A71 Dalmahoy Junction – Options Report

INDEPENDENT STAGE 1 ROAD SAFETY AUDIT

INDEPENDENT STAGE 1 ROAD SAFETY AUDIT

**A71 DALMAHOY
(Signal controlled junction)**

Figure 2/3: Junction Intervisibility Zone (with crossings)

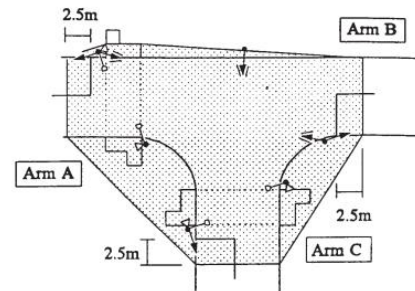
It is noted that the inter-visibility between stop lines and crossing areas is sub-standard due to the buildings and tree/hedge lined boundaries at the existing junction.

Ideally obstructions should be removed to provide the required inter-visibility as per TD50/04: The Geometric Layout of Signal Controlled Junctions and Signalised Roundabouts

Ideally tree lines and buildings should be outwith the inter-visibility zone, however it is appreciated that in existing layouts this is not always possible, especially if there are third party land ownership issues.

At this time the Audit Team cannot recommend any mitigation measures other than those relating to warning signs as discussed in other sections of the report.

It is therefore recommended that the council, as the junction design progresses, records the inter-visibility issue as a Departure from Standard.
